SUBJECT: Forwards response to draft SER Open Item 335 from Structural Engineering Branch. Response supersedes 831027 response, Factor of safety against overturning clarified, Supporting documentation from Ebasco encl.

SHEARON HARRIS NUCLEAR POWER PLANT  
UNIT NOS. 1 AND 2  
DOCKET NOS. 50-400 AND 50-401  
DRAFT SAFETY EVALUATION REPORT RESPONSES  
STRUCTURAL ENGINEERING BRANCH

Shearon Harris Nuclear Power Plant  
Open Item 335  
Second Supplementary Response

SUBJECT RAB UNIT #1 - STABILITY AGAINST OVERTURNING

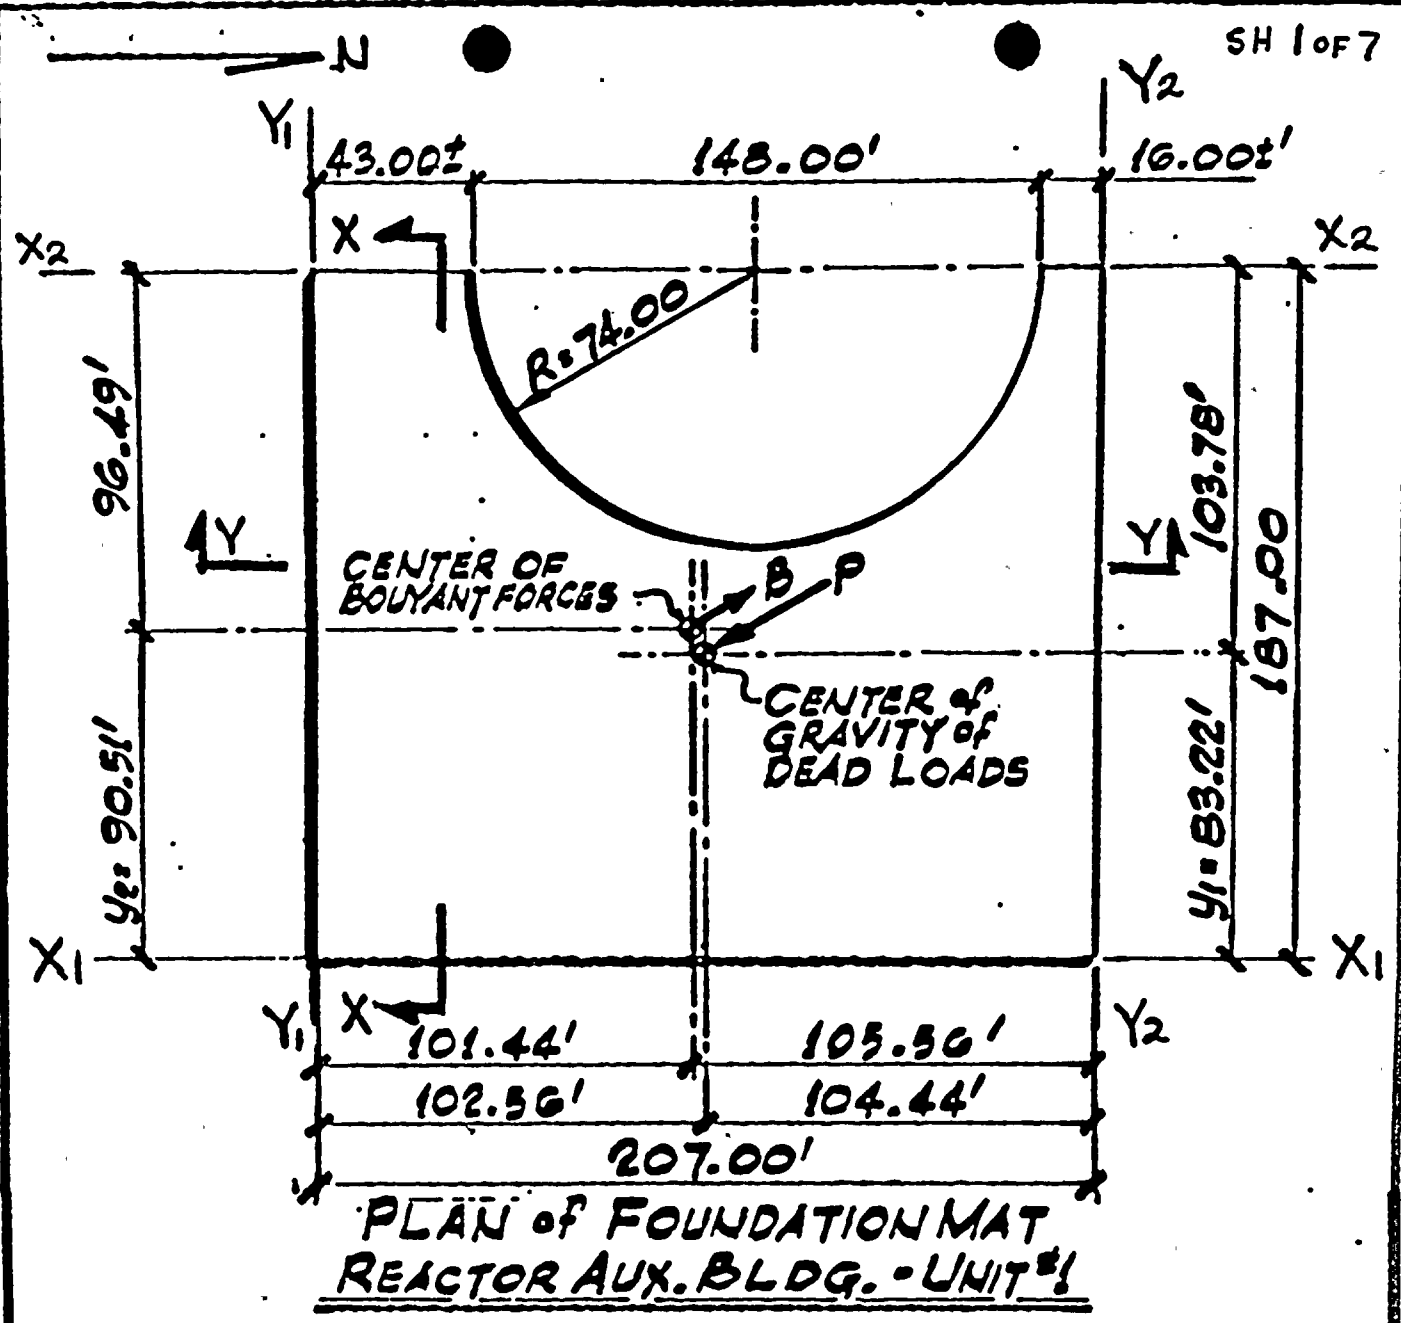
Provide additional clarification on factor of safety against overturning and document the overturning calculations.

The overturning moment for Shearon Harris was calculated by the square root of the sum of the squares of the horizontal acceleration only in both the E-W and N-S directions. The vertical seismic overturning moment was added directly, as 0.4 times the actual moment.

$$M = \sqrt{M^2_{EW} + M^2_{NS}} + 0.4M_v \quad (1)$$

A study was also conducted for Shearon Harris to compute the overturning moment by the SRSS method by taking the square root of the sum of the square of the overturning moments due to the horizontal acceleration in both the E-W and N-S directions, plus the overturning moments due to the vertical seismic uplift forces.

$$M = \sqrt{M^2_{EW} \text{ or } M^2_{NS} + M^2_v} \quad (2)$$

The resisting moment is the vertical load of the building and mat (reduced by buoyancy) multiplied by the distance to the edge of the building.
